Service Bulletin

Title: SB EC145-072120; Airbus Helicopters EC145 Condenser Coil Upgrade

Applicability: Airbus Helicopters Deutschland Model MBB-BK 117 C-1 and C-2 helicopters equipped with the Air Comm Corporation EC145-203, EC145-204-X, or EC145-205-X air conditioning systems

Figure 2: Allowed fastener trimming

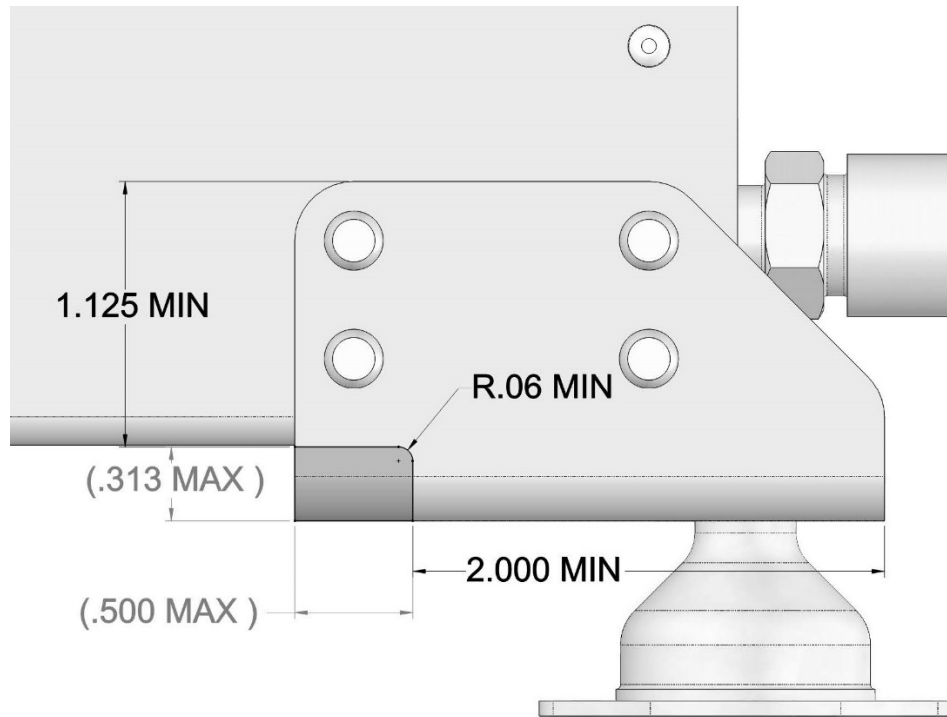
5. If necessary, the aft condenser assembly mount may be trimmed as shown in Figure 2 as required, up to 0.5 in. depth, to obtain clearance between condenser assembly and fairing dzus fastener.

Figure 3: Condenser Installation Clearance

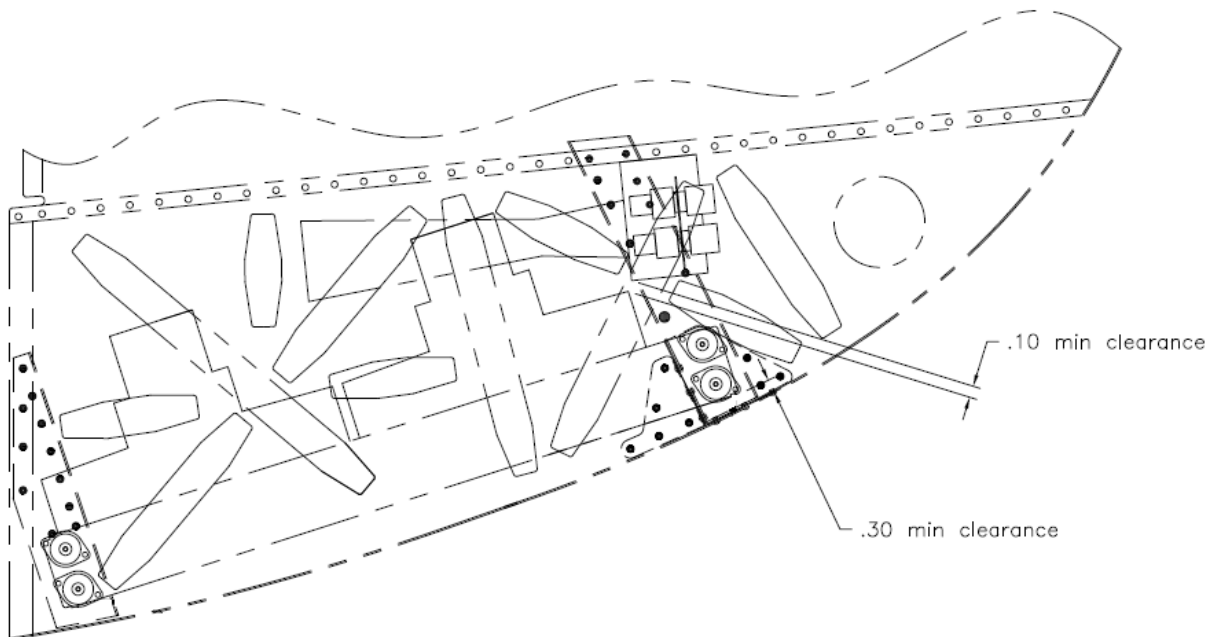
6. After obtaining the required clearance, mark outboard hole location on both tubes. Remove tubes from the aircraft, then drill one $\text{\O}0.171$ hole for screw and one $\text{\O}0.070$ in. hole for safety wire. See Figure 3 for more information.

Figure 4: Support Tube Installation

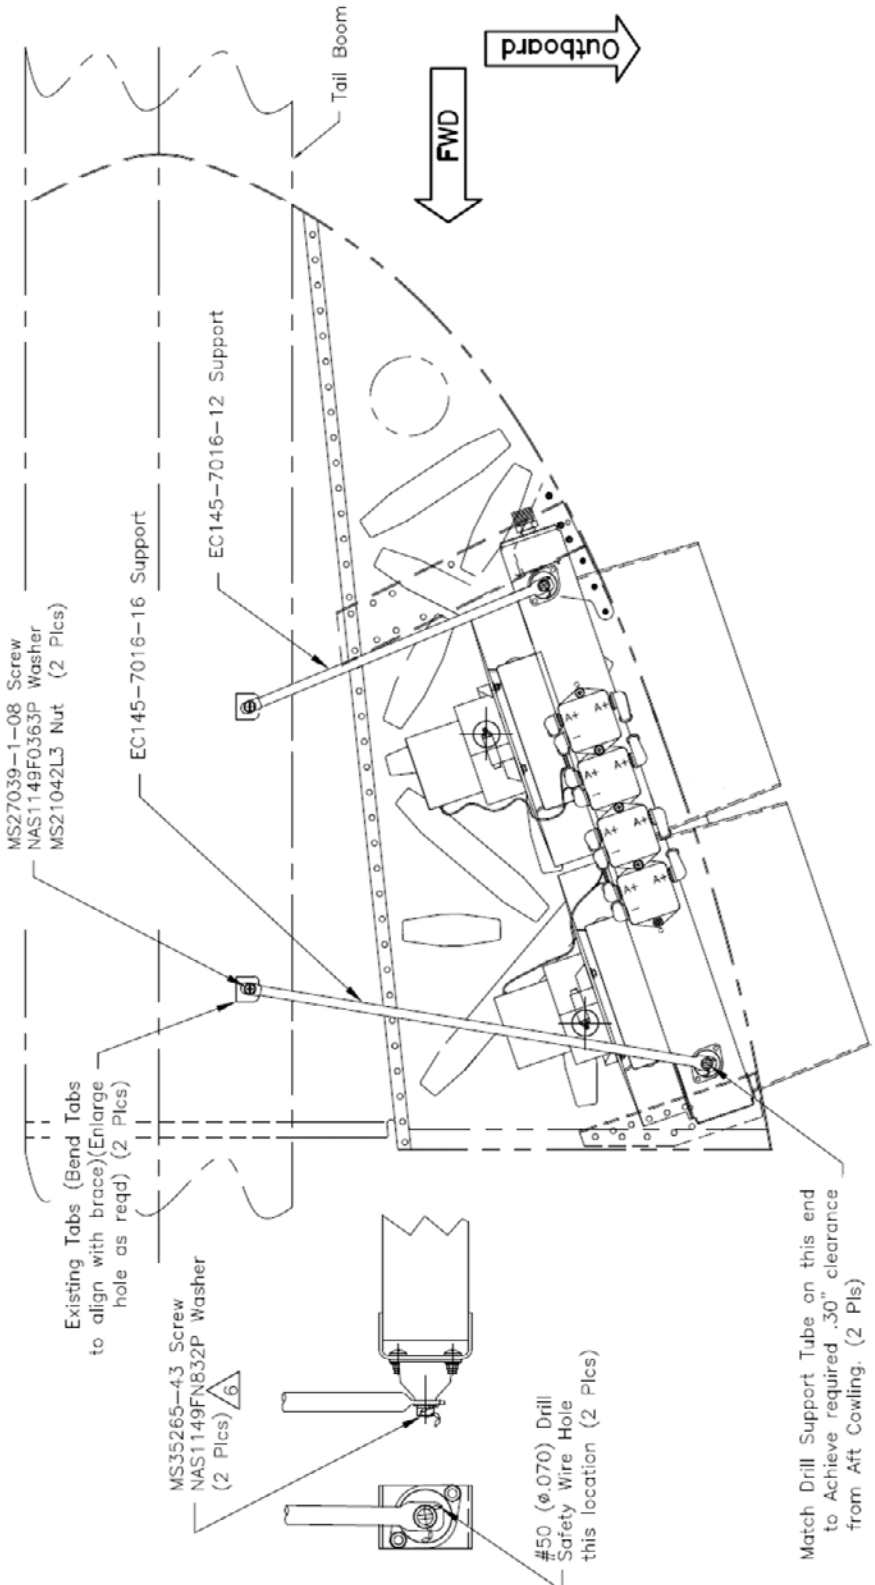
7. Reinstall EC145-7016-12 and EC145-7016-16 Support Tubes per Figure 4 using 2x MS35265-43 Screws and 2x NAS1149FN832P washers for the outboard side of each tube, and 2x MS27039-1-08 screws, 2x NAS1149F0363P washers, and 2x MS21042L3 nuts for the inboard side. Safety wire per MIL-P-8564 paragraph 3.3.7 using MS20995 C32 safety wire.
8. For all other items not expressly noted, reinstall per Air Comm drawing EC145-705-1.
9. Sign off aircraft logbook that S/B EC145-072120 has been performed, and the Air Comm Corporation Air Condenser Installation is EC145-705-1.
